CEMEX INC. BROOKSVILLE PLANT

**RE: *Permitting Projects 0530010-018-AC and -019-AC; Outstanding Questions
CEMEX Cement, Inc., Brooksville Facility*** ~~PSD FL 362~~

Re: DEP File 0530010-018-AC, PSD-FL-362
Projects at CEMEX Brooksville Plant

**Re: Cemex Brooksville Cement Plant
FDEP Project 1050010-019-AC
Cooling Air Dampers for Kiln No. 1
Response to Second RAI**

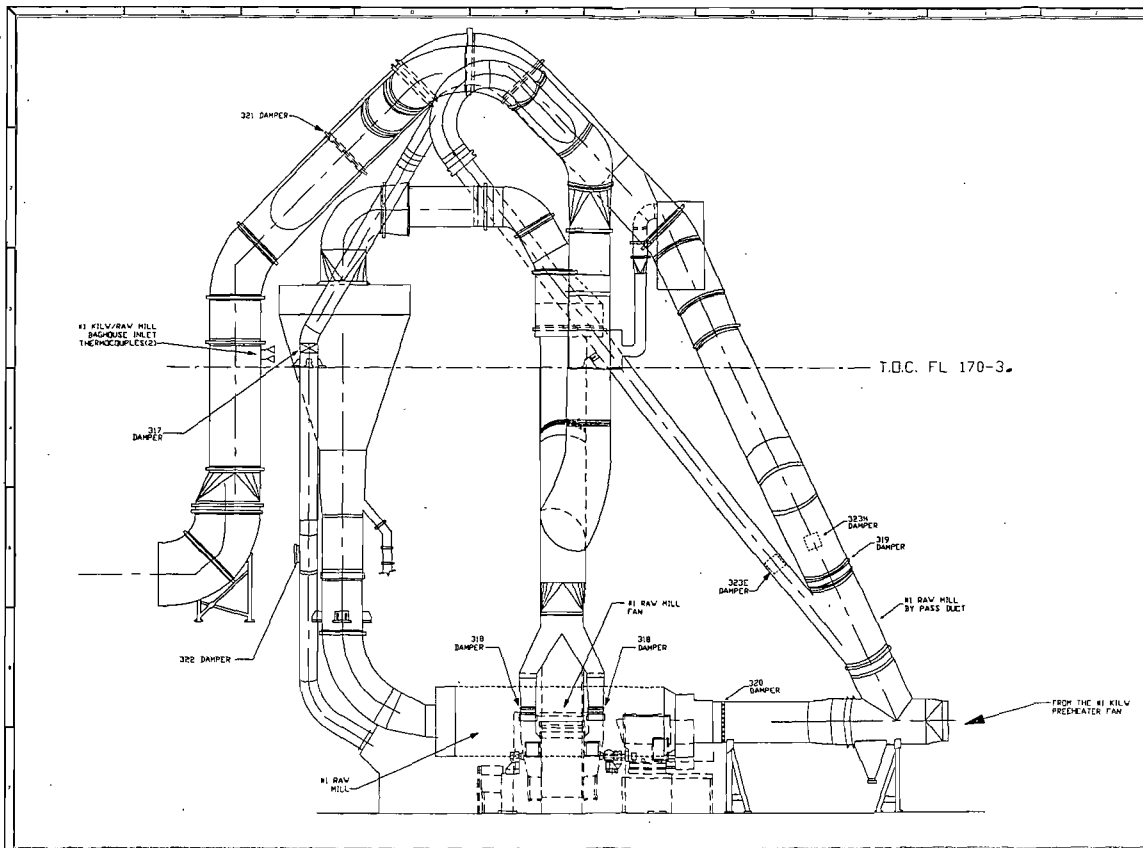
Shut down the raw mill fan when the temperature allows it and close the 2318 dampers.

Fully close the 2322 damper.

Fully close the 2321 damper.

The 2323 fresh air damper will modulate as required to maintain the bag house inlet temperature at less than 395 deg F. The max kiln feed rate of 133 tph cannot be exceeded while the mill is down.

Figure 2

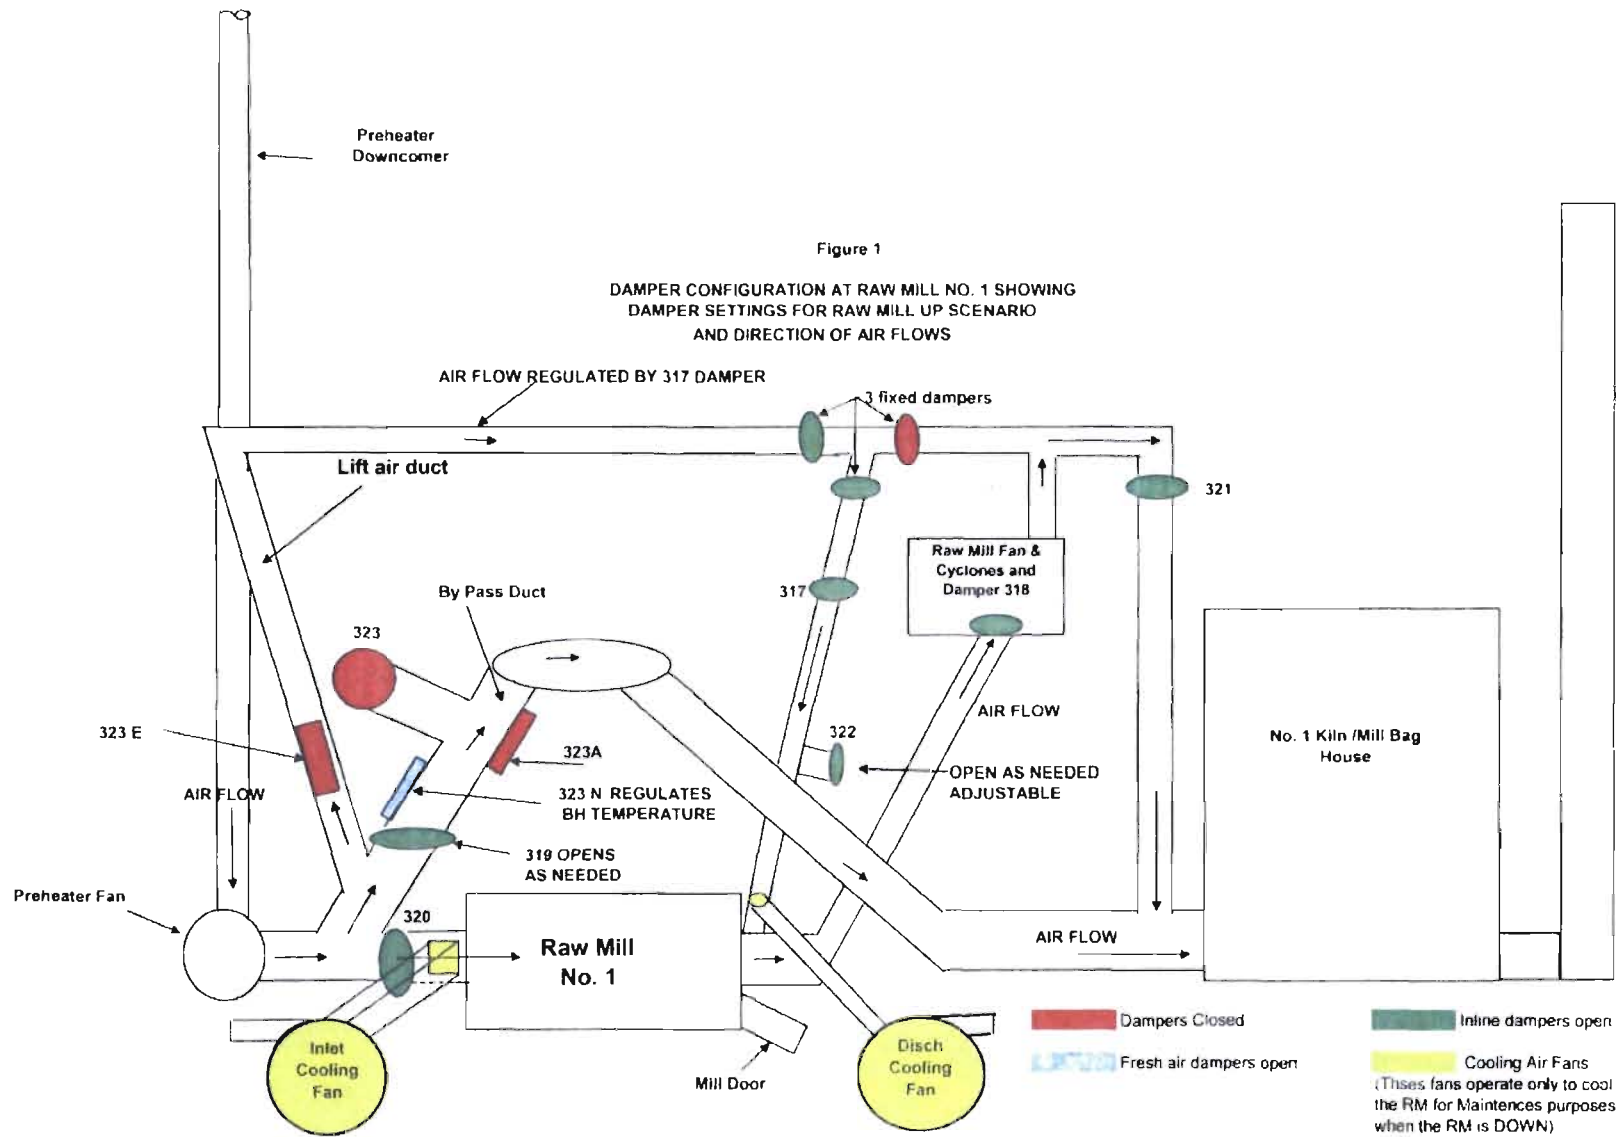
DAMPER CONFIGURATION AT RAW MILL NO. 1 SHOWING DAMPER SETTINGS FOR RAW MILL DOWN SCENARIO AND DIRECTION OF AIR FLOWS

Figure 4: Raw Mill #1 Dampers 323E left side, 323 N rt side.

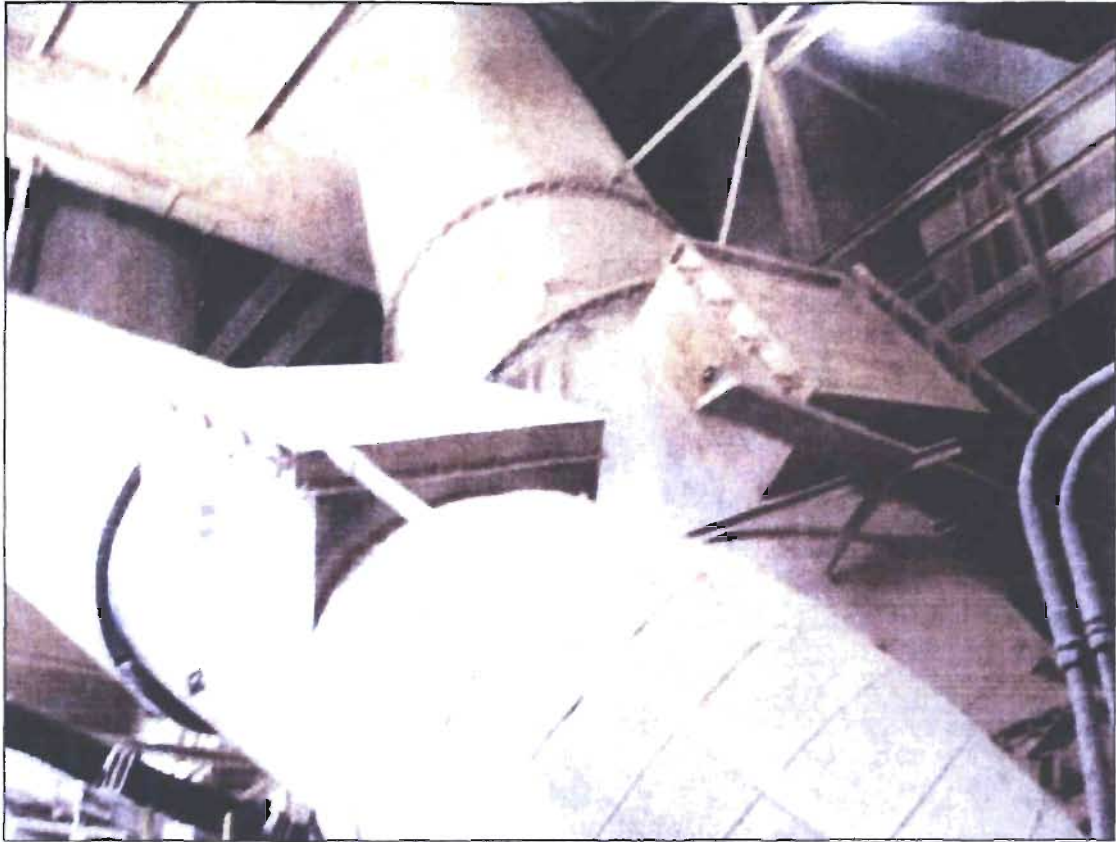
The use of Dampers 323N and 323E to control the temperature of kiln gases bypassing the raw mill in the Kiln No.1 system is not expected to measurably change the raw mill down gas flow rate as measured in the kiln stack. The purpose of these dampers is not to add additional cooling air to the system, the purpose is to add cooling air in a manner that will cool the bypassed gases quickly and uniformly. The placement of the dampers was based on Computational Fluid Dynamic (CFD) modeling and the effectiveness of the dampers has been demonstrated by subsequent D/F performance testing.
